SUPPLEMENTAL INSTRUCTION

PROJ.: **Boys and Girls Club Prince of Wales**
PROJ. No.: **1716**
DATE: **June 15, 2018**
S.I. No. **S.I. - 031**

INFORMATION BULLETIN

Paint Colour PT-1 clarifications

Architectural Drawing A8.01 Ground Floor Finishes

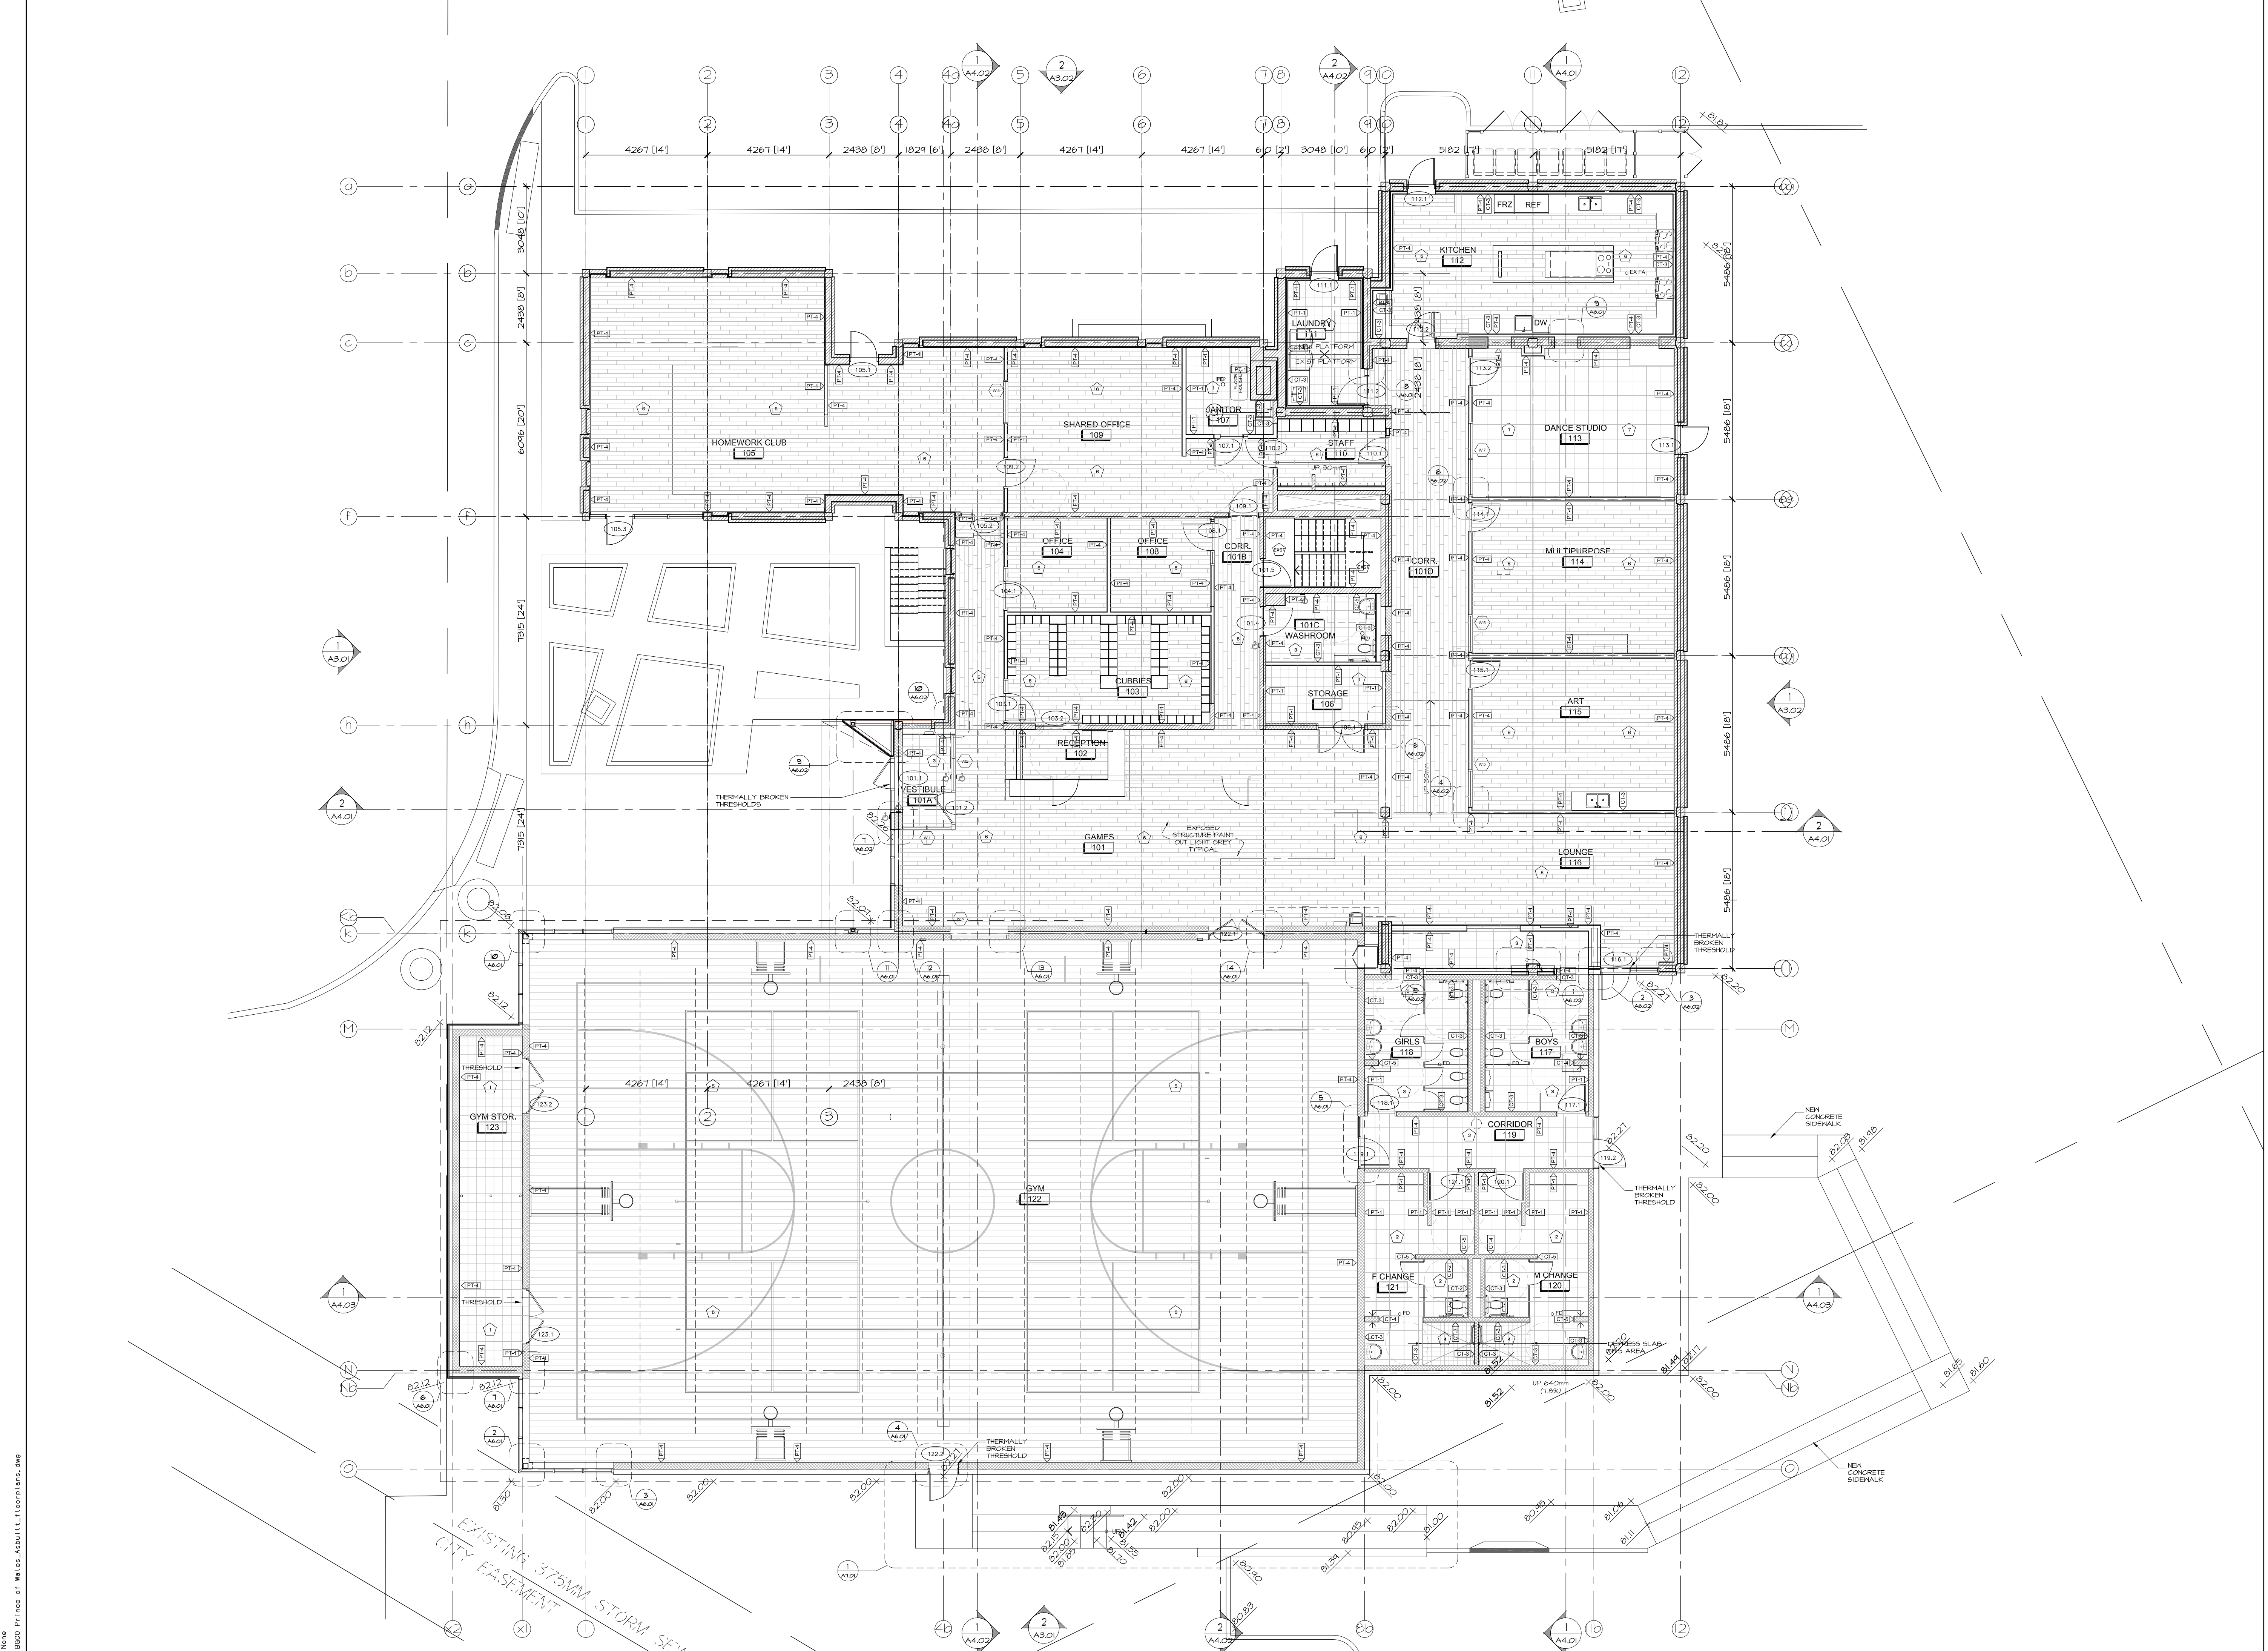
- .1 Refer to revised A8.01 for clarification on paint colours in RM101C, 108, 112, 119, 122, 123
- .2 PT-1 to be CC-40 Cloud White (match to PT-4 colour)
- .3 All PT-1 painted surfaces to be finish G5 (Semi-Gloss)
